NAVY ELECTRONICS LAB SAN DIEGO CALIF
EVALUATION OF BATHYTHERMOGRAPH MODELS OC-1C/S AND OC-2C/S.(U)
JAN 58 J E ROBERSON
NEL-827

EVALUATION REPORT,
REPORT 827

EVALUATION OF BATHYTHERMOGRAPH MODELS OC-1C/S AND OC-2C/S.

Evaluate preproduction samples of surface-vessel bathythermograph models OC-1C/S and OC-2C/S for compliance with specifications.

FIGURE 7

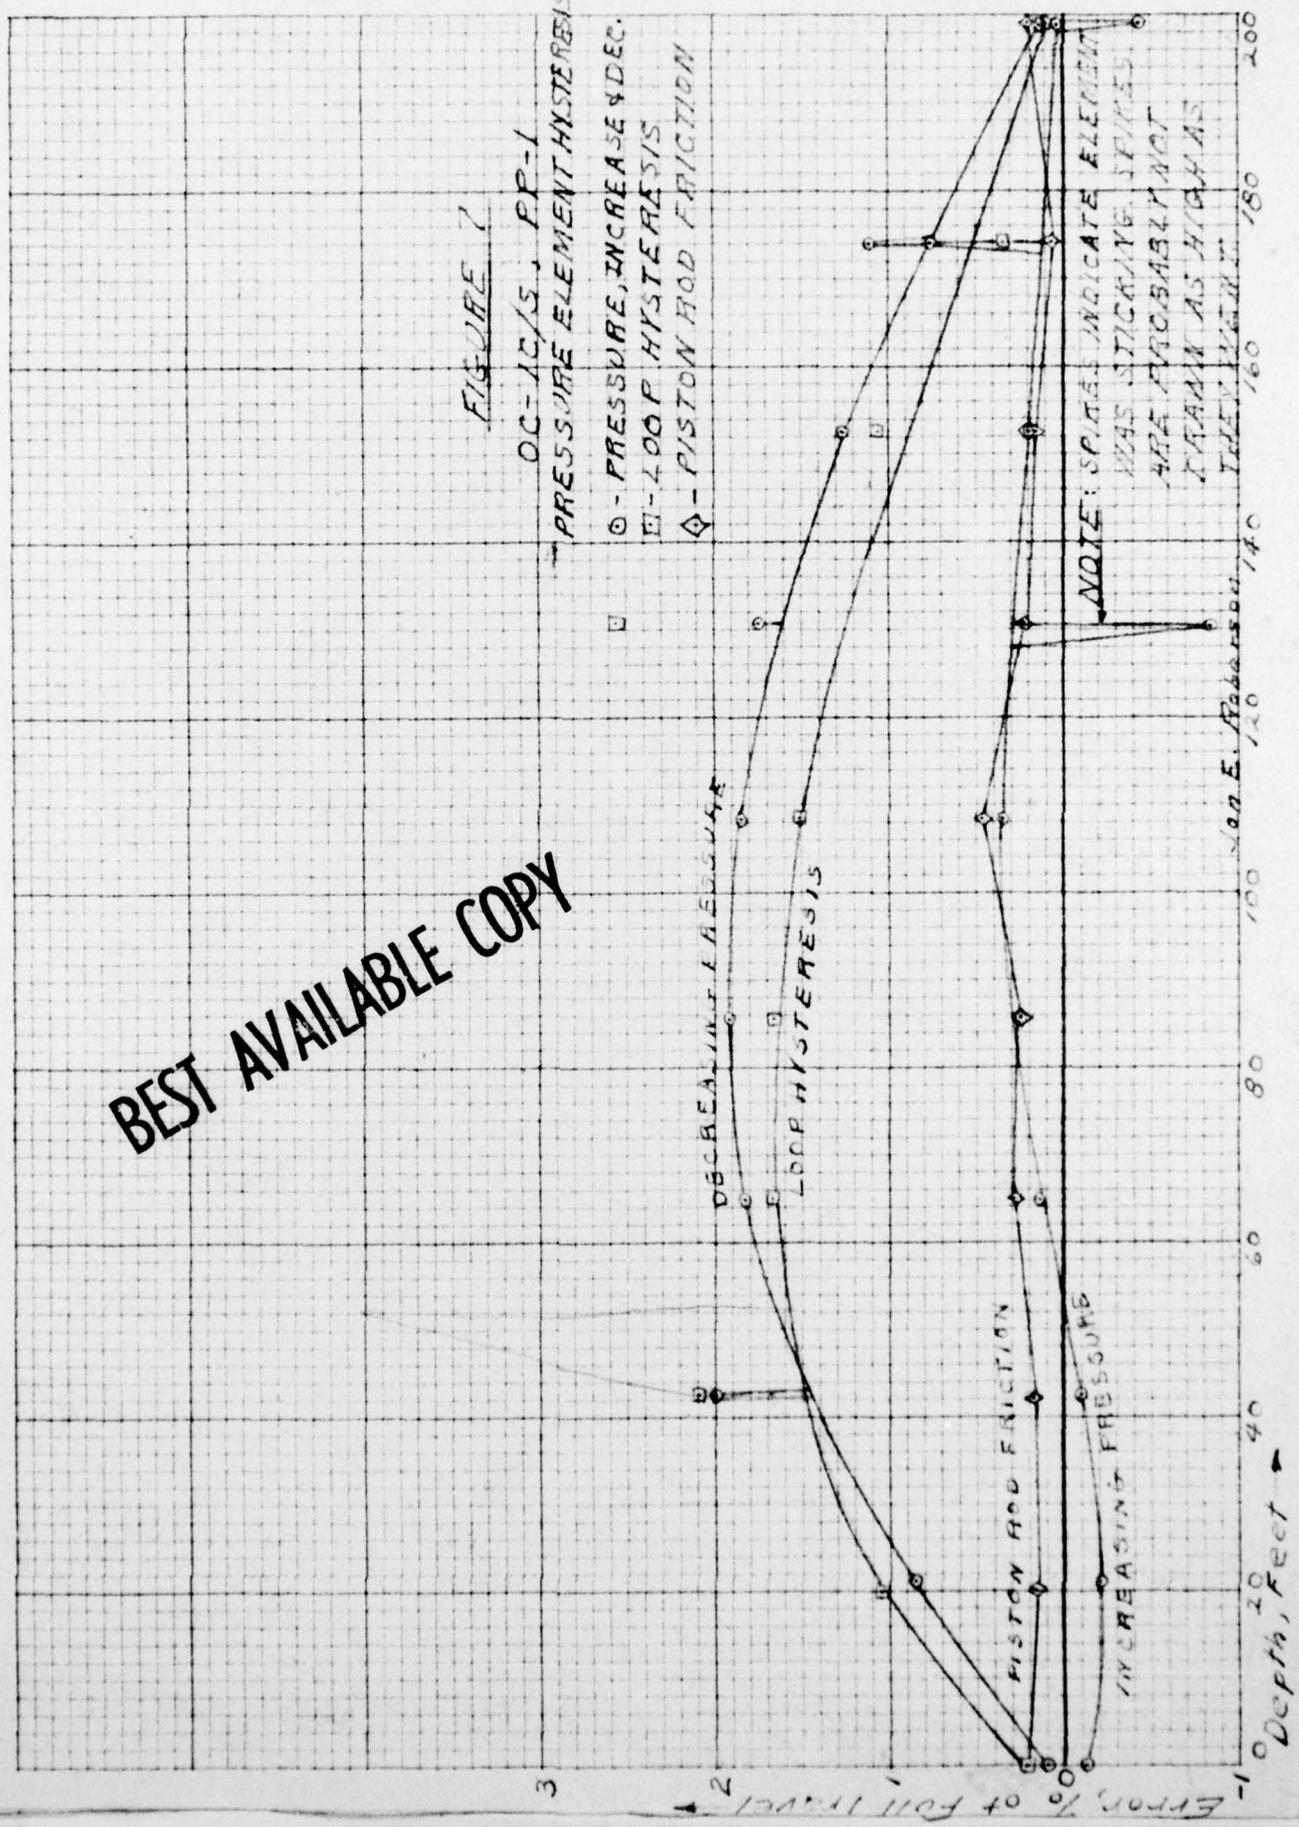
Figure 7 shows the loop plots, which give the departures of the data from a straight line fit. The curves of increasing and decreasing pressure show four points where the element appears to have jammed. The element was also seen to jump about 0.01 inch (1.5 per cent of full travel) on two occasions during the test between 10- and 40-foot depths. A jump of 0.01 inch corresponds to a 2.6-pound breakaway

force. A later examination showed that the spiral groove on the piston rod would catch on the edges of the bushings if a small lateral force was exerted, such as might be expected from a slight eccentricity of the spring. (It is almost impossible to make the spring force concentric with the piston rod.) The snagging of the groove might have caused the peaks of the curves. If the peaks are ignored, the loop hysteresis assumes a regular shape with a maximum of 1.3 per cent. The loop hysteresis is excessive.

The curves in figure 7 show that the hysteresis and compliance variation opposed each other during the trace of increasing depth, causing it to be quite straight (within 0.6 per cent and better) and the trace of decreasing depth to be noticeably curved (within 1.3 per cent). Therefore, readings of either increasing depth or of an average of increasing and decreasing depths will best meet the 1 per cent requirement.

3. Eliminate the abnormal piston rod friction found in the hysteresis tests. This can be done by increasing the pitch of the spiral groove or eliminating the groove, and rounding the bushing edges.

6. Reduce the nonlinearity of the pressure elements to 1 per cent or less on the traces of decreasing depth, and reduce the loop hysteresis to 1 per cent or less.

FIGURE 8

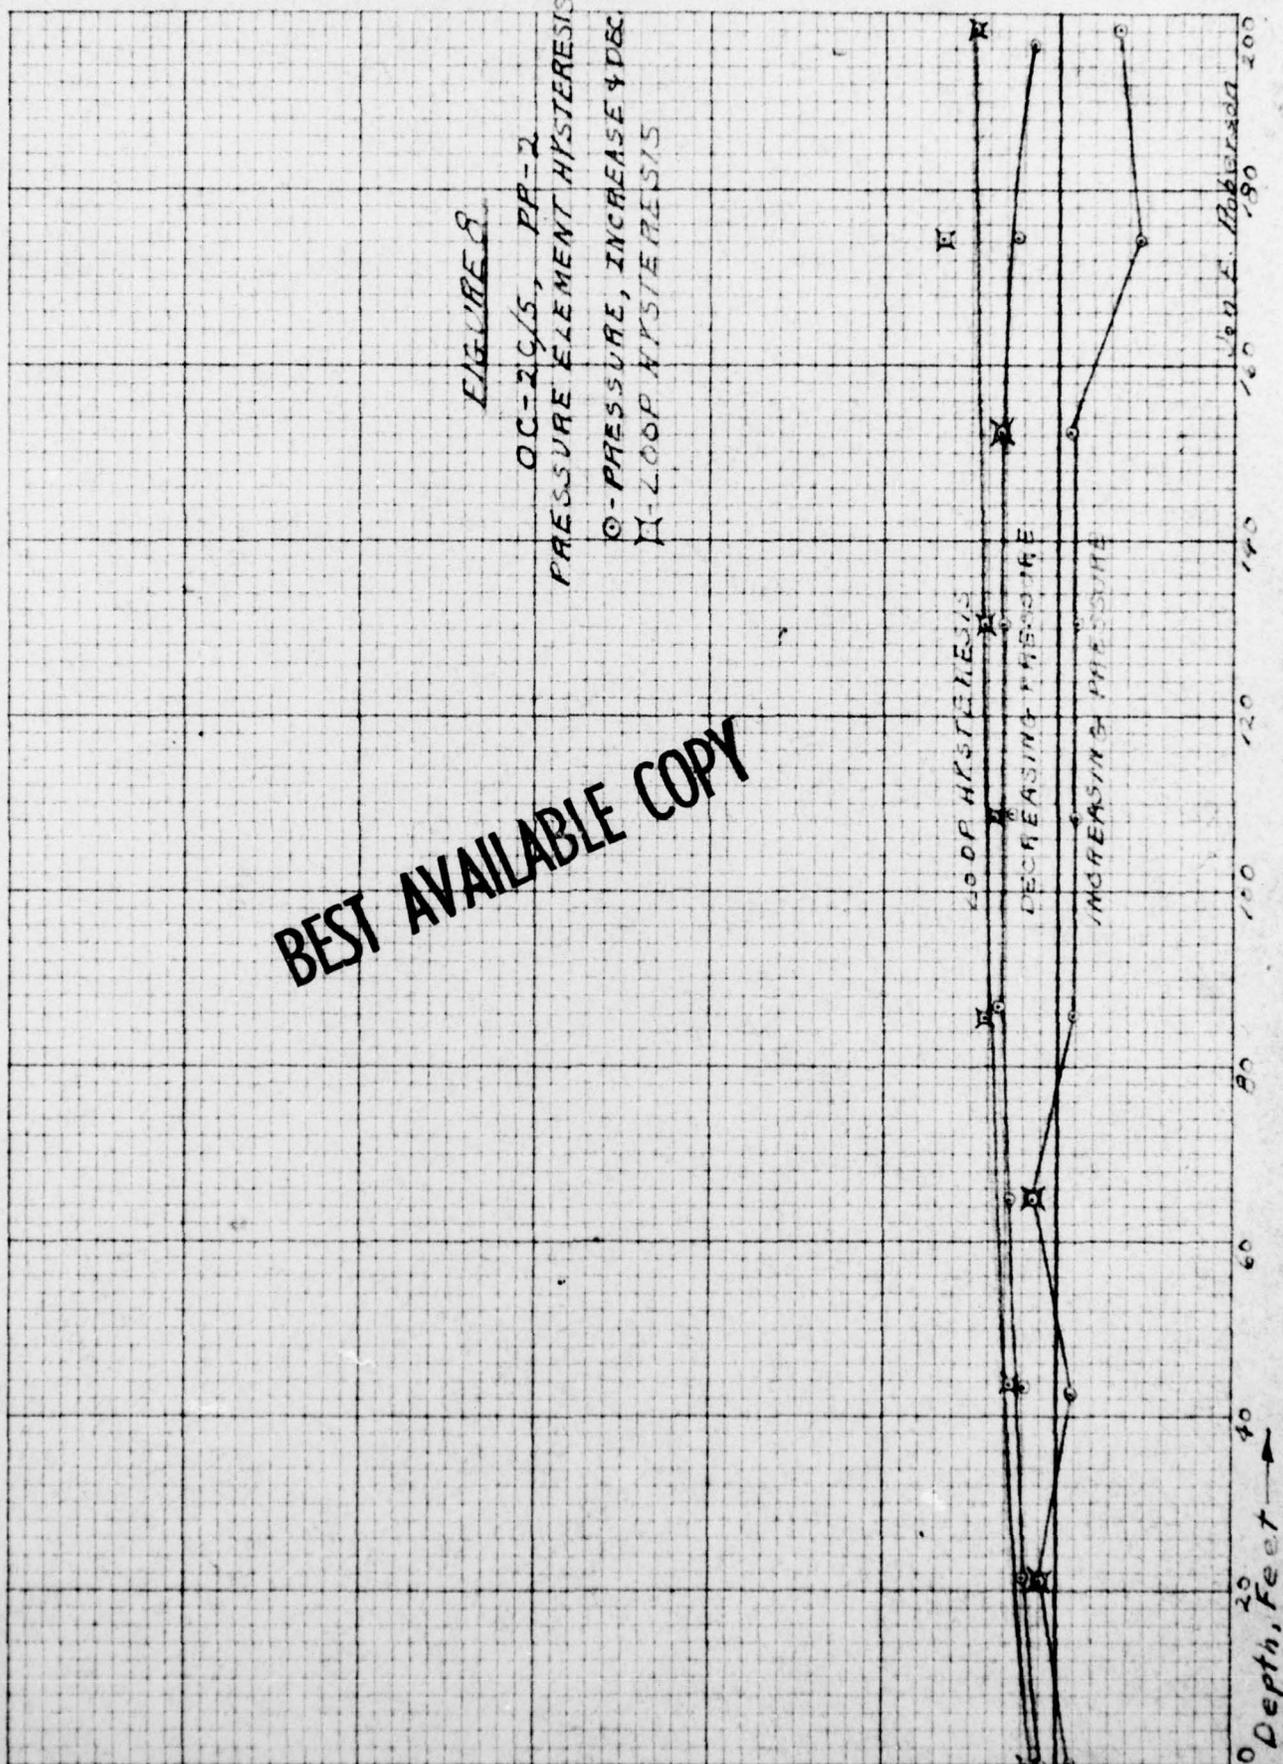
A full-depth loop test was made on the element, but the readings extended to only 44 per cent of full depth, which was the limit of the manometer. The curves appear in figure 8 and are similar to figure 7. The point friction was not measured. The maximum loop hysteresis is about 0.50 per cent. Abnormal friction shows only on the curve of increasing depth and is about 0.3 per cent. The element was not seen to jump during the test.

The PP-1 element has more abnormal piston friction and hysteresis than the PP-2 element because the stiffer spring of the latter overrides the defects. If the ordinate of figure 8 is multiplied by 450/200 to correct for the spring, the values for PP-2 are still somewhat less than those for PP-1. The results indicate that most of the loop hysteresis is in the bellows.

Figure 9. PP-1 Bellows crack.

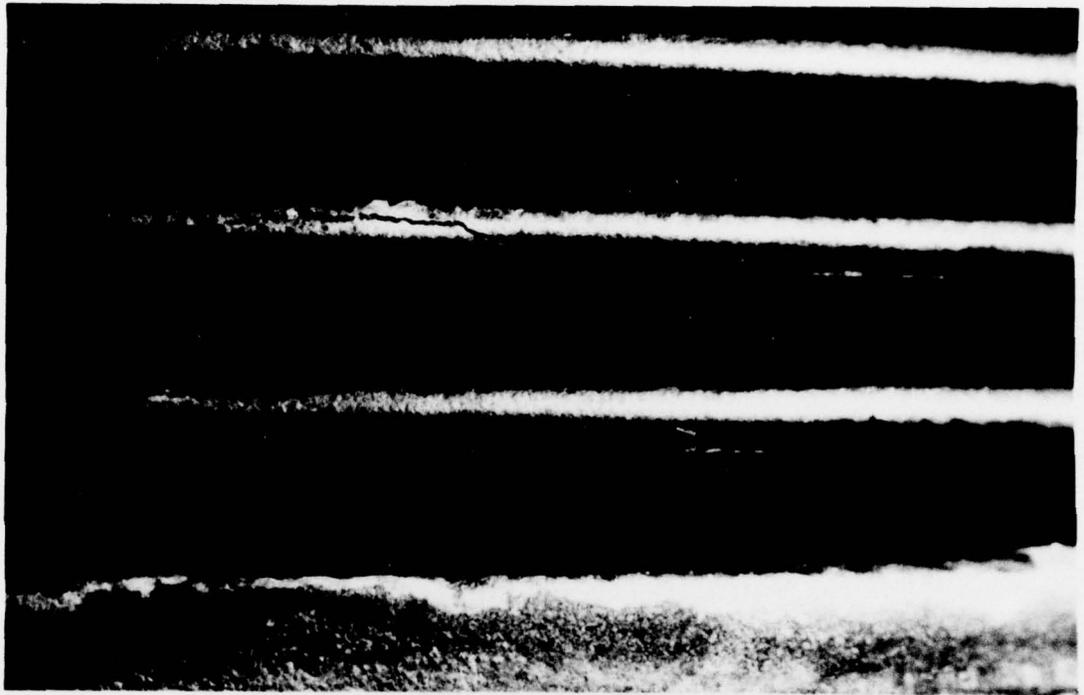
The specification requires the elements to withstand 100 full depth pressure cycles and 125 per cent of full depth pressure without permanent deflection or other damage. The PP-1 sample was accidentally dropped to 200 per cent of full depth pressure during the sea trials. The excessive pressure did not cause failure at the time. During the life test the bellows cracked at the 23rd cycle, and the element filled with water. The element had received about 35 cycles in previous tests, giving 60 cycles at failure in addition to those received at the factory. The test was continued to the 43rd cycle to make the cracks more obvious. The cracks found were on the second and sixth outer folds from the base, as shown in figure 9.

The accelerated life and overpressure tests disclosed cracks on the outer folds of the bellows nearest the bases of the elements. The outer folds have a much sharper bend radius than the inner ones and therefore fail first. The rough and grainy appearance of the outer folds shows that the metal has been excessively deformed and is metallurgically unsatisfactory. The bellows appear to have been hydraulically formed, resulting in crimped outer folds. The base bellows might have failed because they were heat treated more severely than the others during soldering of the base.

5. Study and eliminate the causes of bellows failure.
